FORMAL THIRD PARTY OBSERVATION FOR CASE NO. 324162

Development: Construction of an Open-Cycle Gas Turbine Power Plant, Above Ground Installation and Ancillary Development

Location: Pollnagroagh and Rathmorrissy (Townlands), Athenry, Co. Galway

Applicant: Bord Gáis Energy Limited

Existing Pillars and boundary stone wall to my property alongside the proposed Entrance.

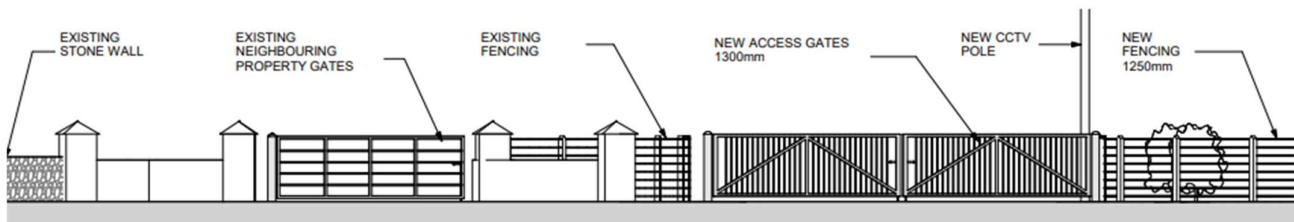
My entrance is defined by original stone pillars over 100 years old. They are not decorative — they are structural and heritage elements of a period dwelling constructed to last. These pillars sit immediately adjacent to the proposed site entrance on a bend.

The sightlines drawing (PEK3-ATK-ZZ-01-DR-CE-901200) shows sightlines can only be achieved by removing multiple trees, demolishing and setting back existing stone walls, and relocating utility poles. Even after these interventions, sightline achieved is approximately 90 metres — inadequate for a junction generating sustained HGV traffic on a road with a continuous white centre line.

Image above taken from applicants drawing; PEK3-ATK-ZZ-ZZ-DR-A-ATK-000040, This shows my Existing Pillars and Entrance to my property alongside the proposed Entrance.

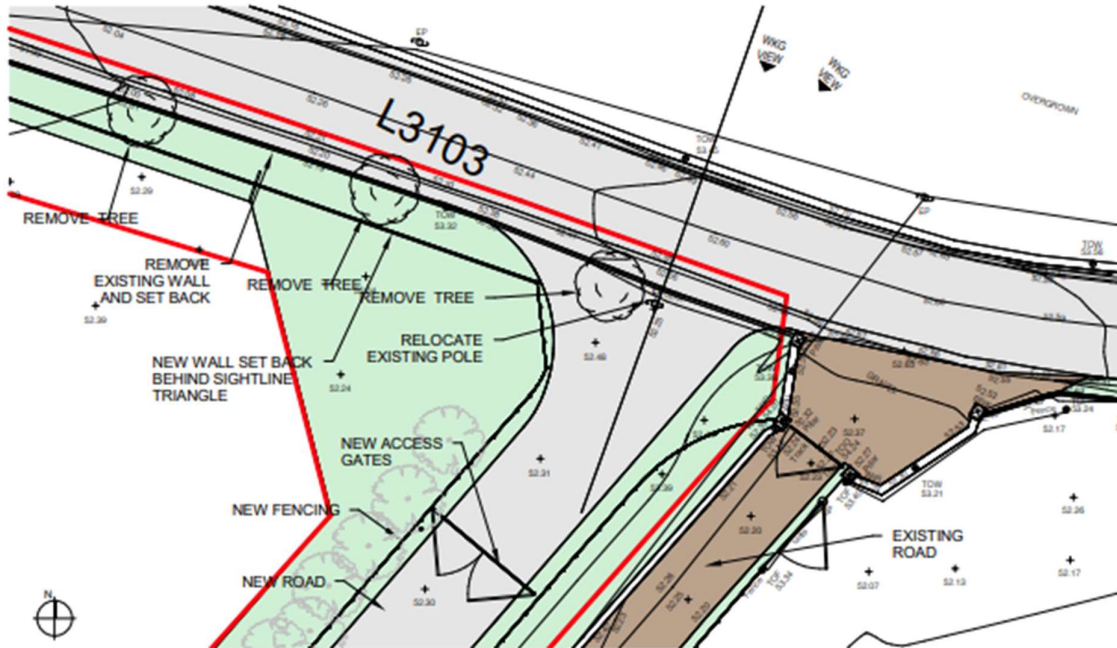
The applicant's own Autotrack drawing (PEK3-ATK-ZZ-01-DR-CE-901200) demonstrates that 18-metre articulated lorries cannot complete the turn into the site entrance without crossing into the oncoming lane of the L3103. This is not interpretation — the swept path shown in the engineer's own drawing occupies the full carriageway width and extends comprehensively into opposing traffic.

Vehicle specification used (ETA Design Articulated Vehicle 2018): Overall length 16.460m, width 2.550m, kerb-to-kerb turning radius 6.600m. The L3103 is a narrow rural local road not designed for repeated HGV turning movements. Any vehicle approaching from the opposite

The continuous white centre line at this location is a formal road marking under the Road Traffic (Signs) Regulations indicating that visibility and alignment are insufficient for safe overtaking. Galway County Council cannot rationally maintain this safety marking while approving a new industrial access generating decades of HGV traffic at the same point.

This image is taken from the Applicants tree survey report drawing ;25026_TS Sheet 5

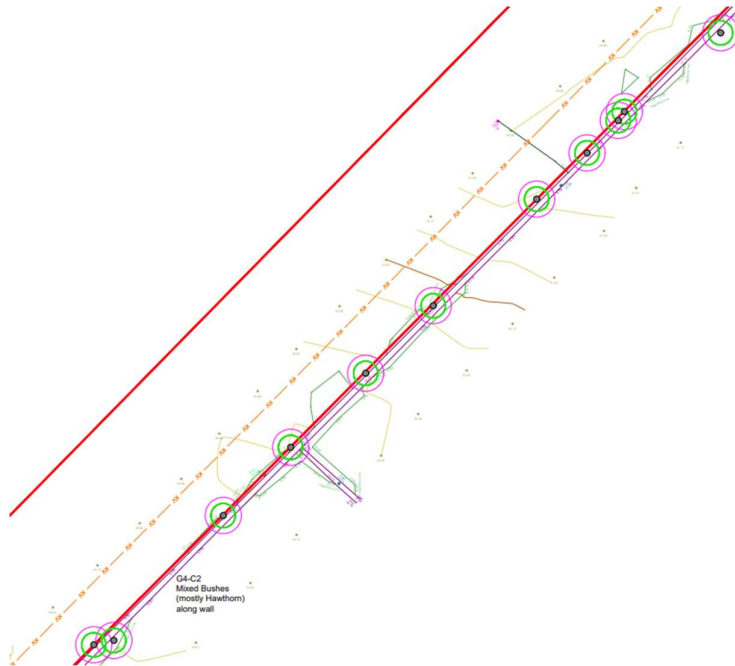
G4- C2 Mixed Bushes, you can clearly see they are outside the proposed site boundary and within my landholding (please see a copy of my Folio map attached as a reference)

Below is an extract from page 12 of tree survey, proposing to remove 45 of these hawthorn bushes which are in my boundary wall.

This image is taken from the Applicants tree survey report drawing ;25026_TS Sheet 3
 G4- C2 Mixed Bushes, you can clearly see most of these are on our site boundary and some within our shared stone wall, which are proposed to be removed.

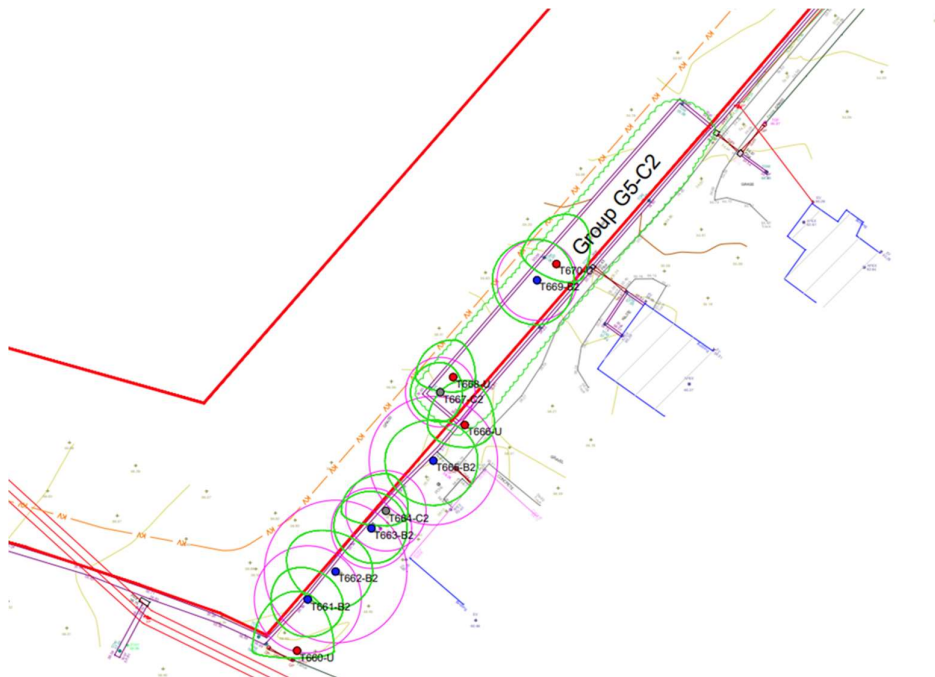
“This new road will require that a section(approx. 15m wide) of tree group G2 will need to be removed as the new road joins the new facility, along with a series of small (mostly Hawthorn) bushes making up part of group G4, that are growing alongside the old field boundary wall located to the northeast of the site. Approximately 45 of these bushes will need to be removed to allow for the construction of the new road and fencing.”

This image is taken from the Applicants tree survey report drawing ;25026_TS Sheet 5
 Group G5 is described as a group of self-sown Sycamore, Ash, and Elder growing alongside the old stone wall just outside the site boundary, with “some potential for limited root spread out into the project site.” The Tree Survey explicitly notes G5 is located outside the site boundary — which means it is within or immediately adjacent to my land.

The Tree Survey Report at Section 7 (Arboricultural Impact of the New Development) states that the proposed new access road, which will carry the grid connection cable, will require the removal of approximately 45 bushes making up part of Group G4, and that Group G5 — including trees T667, T668, T669, and T670 — will be removed to facilitate the road and fence layout where it extends toward the junction with the L3103.

The Tree Survey at Section 8.1 (Tree Work Operations) lists the following as proposed to be felled to facilitate this development: Group G5, trees T667, T668, T669, and T670, and approximately 45 bushes in Group G4. Additionally, Ash saplings and small Hawthorn bushes on the roadside immediately west of the new junction with the L3103 may be removed if they interfere with necessary sightlines.

Figure 12-3 - Groundwater Bodies underlying the Proposed Project (EPA, 2025).

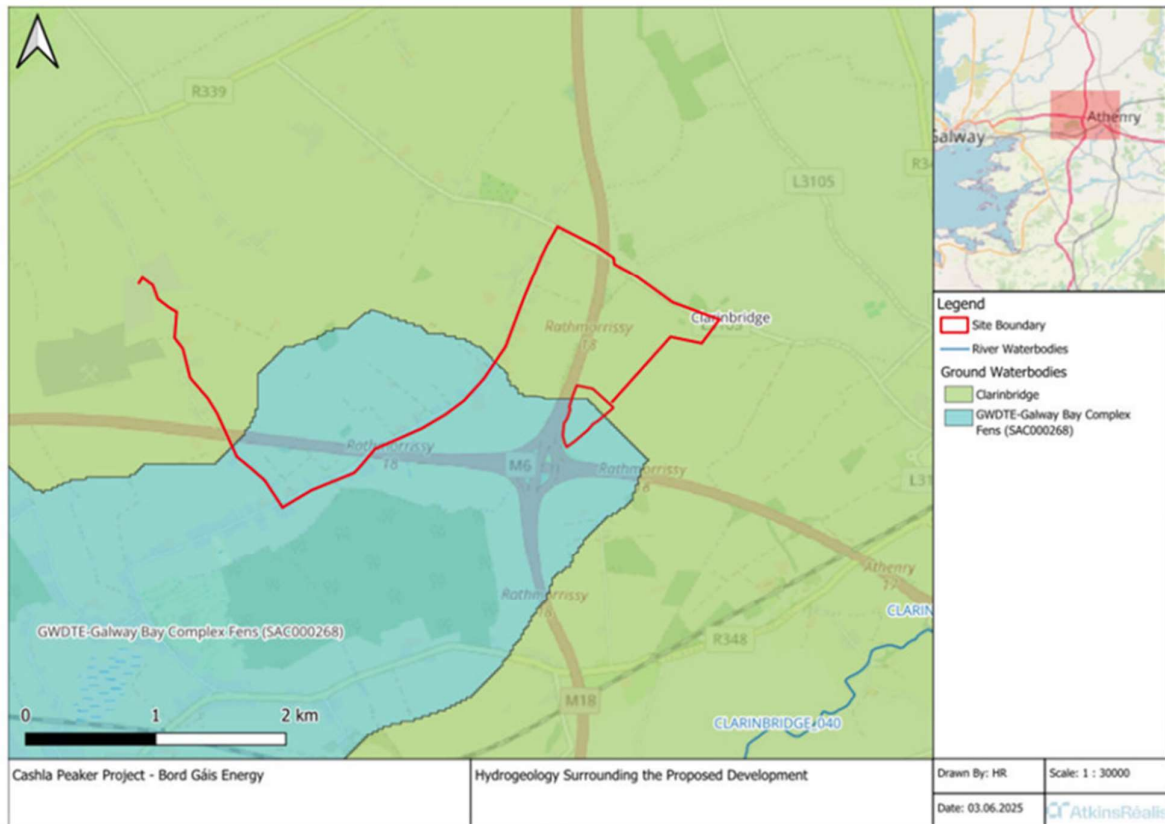
The EIAR (Volume 2, p. 574) confirms that part of the proposed development site — including sections of the access track and underground cable route — is underlain by a Groundwater Dependent Terrestrial Ecosystem (GWDTE) that is **directly connected to the Galway Bay Complex Fens (SAC000268). This GWDTE is connected to a Special Area of Conservation.** The EIAR assigns it “*extremely high importance*.”

Let me say that again in straightforward terms. There is a protected European ecosystem — one formally connected to a Special Area of Conservation under the Habitats Directive — inside the boundary of the proposed development. Not beside it. Not near it. Inside it. Construction, excavation, hardstanding, access roads, underground tanks, and industrial infrastructure are being proposed on top of and around an ecosystem that is legally protected under European law and that the applicant's own consultants have given the highest possible importance rating.

The Galway Bay Complex SAC (SAC000268) is **one of the most significant Natura 2000 designations in Ireland**. Its qualifying interests include turloughs, alkaline fens, Cladium fens, orchid-rich calcareous grassland, and limestone pavement. These are not common habitats. They are rare, internationally protected, and directly dependent on the quality and flow of the groundwater that moves through the karst system beneath this site and beneath my farm.

Applicants EIAR (Volume 2, p. 573) shows Galway Bay complex Fens in blue and Clarinbridge Groundwater body in green.

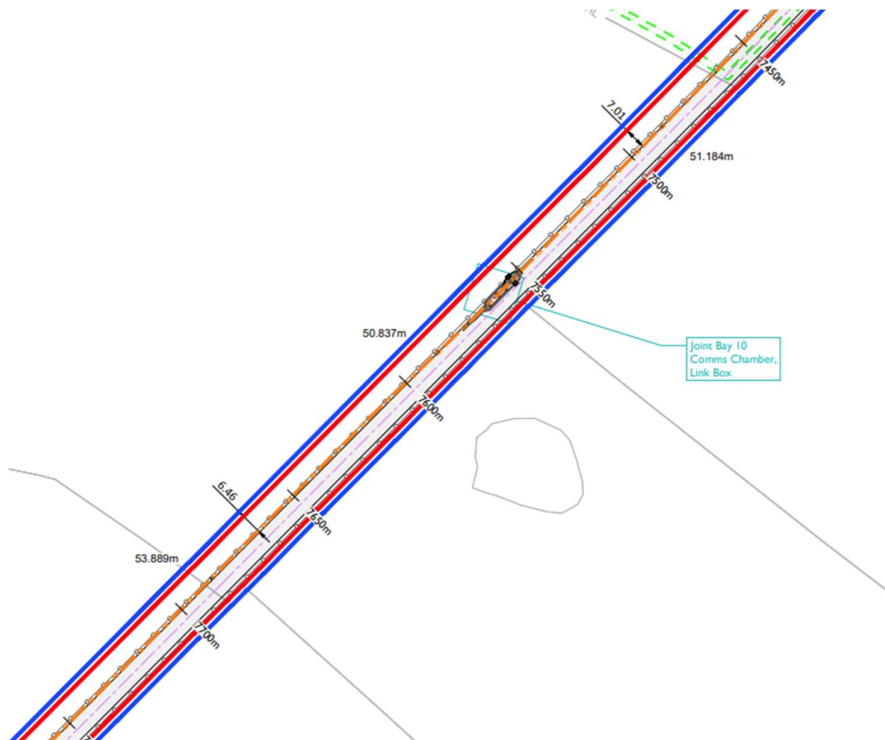
The applicant's own bird survey (Appendix 5.1, Delichon Ecology, 2025) records two circular ponds located approximately 260 metres west/north-west of the proposed access road. These ponds are described in the survey as being *"most likely fed by groundwater"* and as providing *"the most suitable habitat for wintering birds within the study area."* The survey records Mallard using these ponds during the December 2024 site visit, Golden Plover foraging on the adjacent grassland in January 2025, and Snipe — a Red-listed species under the Birds of Conservation Concern in Ireland (BoCCI) 2020–2026 list — flushed from the improved grassland within and north of the peaker plant footprint during multiple survey visits. During the breeding bird surveys of May and June 2025, Mallard, Moorhen, Swallow, Sand Martin, and House Martin were all recorded using these ponds and their margins as foraging and habitat sites.

If a contamination event reaches this groundwater, it will reach these ponds. It will reach the species that depend on them. It will reach my well. In a conduit aquifer, these outcomes are not sequential risks to be weighed and balanced. They are simultaneous pathways through the same connected system.

The bird survey identifies these ponds as **the principal wildlife habitat value in the study area**. The EIAR does not identify them as a groundwater receptor requiring protection from the proposed development. No contamination pathway assessment from the site to these ponds has been carried out. No baseline ecological survey of the ponds themselves — their water chemistry, invertebrate communities, or species-specific usage — has been conducted. The applicant has recorded the habitat value of these ponds and has not protected them.
